UN Regulation No. 129 (Enhanced Child Restraint Systems)**Proposal for Supplement 4 to the 01 series of amendments to
UN Regulation No. 129 (Enhanced Child Restraint Systems)****Submitted by the expert from France***

The text reproduced below was prepared by the expert from France on behalf of the Technical Services Group (TSG) on UN Regulation No. 129 to clarify the test protocol for the opening force of the ISOFIX attachments. The modifications to the current text of UN Regulation No. 129 are marked in bold for new or strikethrough for deleted characters.

"Figure 3

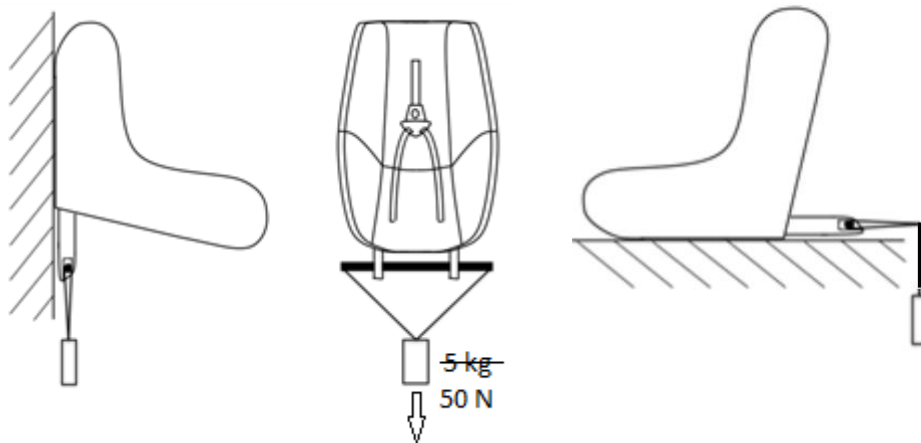
"7.2.8. The complete seat, or the component fitted with ISOFIX attachments (e.g. ISOFIX base) if it has a release button, is attached rigidly to a test rig in such a way that ISOFIX connectors ~~are vertically~~ aligned as shown in Figure 3. A 6 mm diameter bar, 350 mm long, shall be attached to the ISOFIX connectors. A ~~mass force of 5 kg~~ **50 ± 1 N shall be applied to the** ~~shall be attached to the~~ extremities of the bar."

Figure 3, amend to read:

Either option is permitted as long as a force of 50 N is applied.
